Technical Note

Project:	P16-530 Land at Newark Road, Sutton-in-Ashfield		
Subject:	Technical Note – Flooding and Drainage		
Prepared by:	Matthew Leask – Associate	Date:	6 January 2025
Authorised by:	Kriston Harvey - Director	Status:	S2 - Information
Document Ref:	16530-RLL-24-XX-TN-C-0003	Revision:	P03

Figure 3: Proposed Land Drainage (FRA)

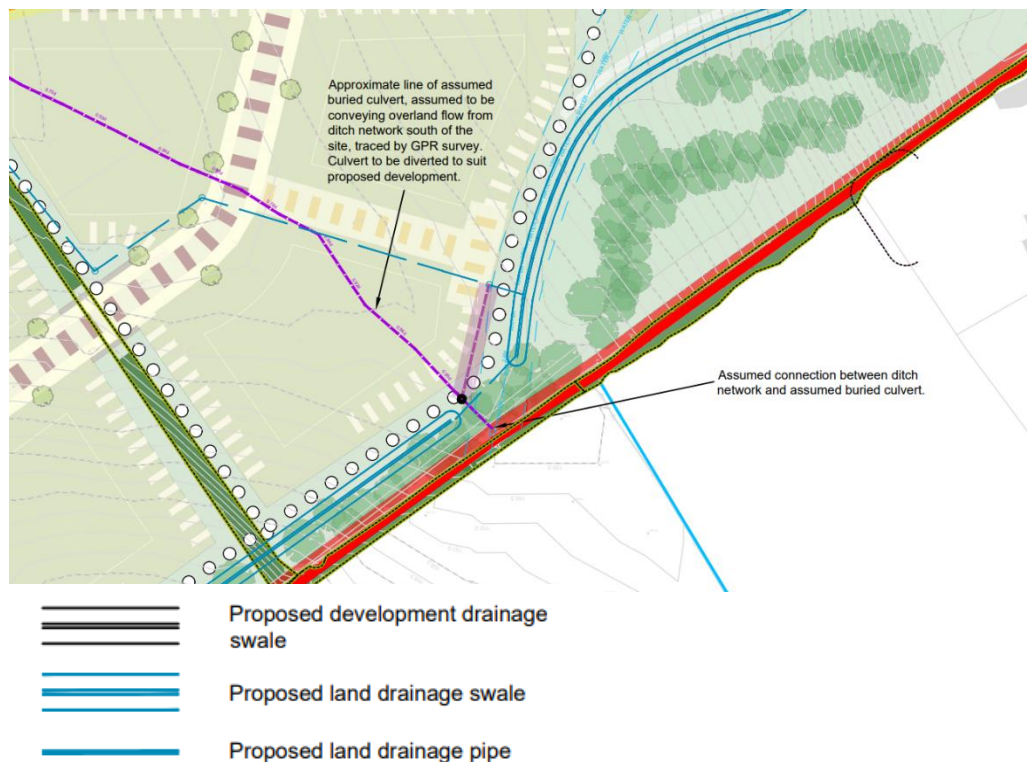
Cllr Relf expresses concerns that the Site is impacted by surface water and ground water flooding and that the application does not adequately take this into account. The statement identifies an overland flow path that runs from the southern boundary to the apex of the inverted ‘L’ shape of the site (referred to as “the Site”). Cllr Relf attributes the flows to a watercourse that runs from the ditch immediately south of the Site, and then across the Site, that he says becomes overwhelmed during periods of heavy rain. The statement includes a photo of a channel within the Site, which is taken at a point adjacent the back gardens of properties on Searby Road in the approximate location of the

proposed SUDs basins. Cllr Relf raises concerns that the layout does not take into consideration this overland flow path.

At Appendix F, the FRA contains a drainage strategy drawing, with reference 16530-RLL-17-XX-DR-C-201 Revision E. The drainage strategy drawing clearly shows proposed land drainage features along the southern boundary of the Site, including pipes and swales (refer to Figure 3). These features have been proposed to intercept any potential overland flow, and convey these flows using a positive, controlled drainage system. With the new system in place, the existing buried pipe could be removed as it would become obsolete.

The swales will be planted and include baffles or check dams that will slow flows, which will increase the time of entry into the receiving drainage network. The downstream

pipework will convey flows away from the proposed housing, through the illustrative layout and towards the existing ditch that runs along the western edge of the Site.

Replacing the existing 150mm diameter pipe with a network of appropriately sized SuDS swales and pipework, will provide significant betterment to the existing situation. This will address the low level flood risk, on-site and off-site.
